# Service Kit 753-04874

Date: August 5, 2004

Subject: 734-0968 Replacement Wheel

FIGURE 1

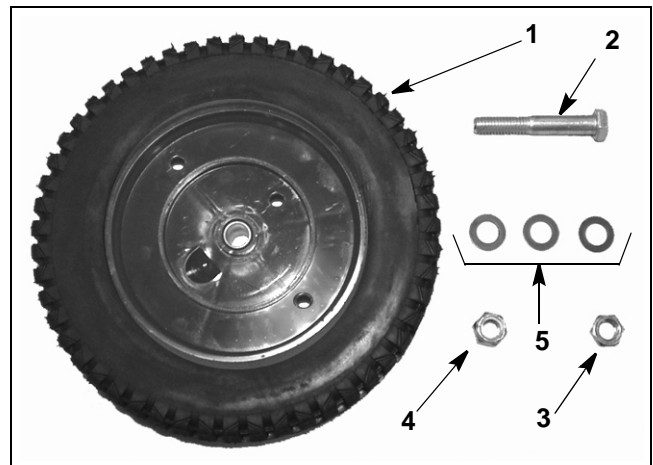
**PURPOSE:** Use this kit when replacing Wheel and Rim Assembly, 734-0968 (9" diameter x 1.75" wide with a 5/8" bore plastic hub), which is no longer available. The replacement Wheel and Rim Assembly, 734-2010A, is a 9" diameter x 2.12" wide with a 1/2" sleeved bore hub. Hardware is supplied to adapt the new wheel.
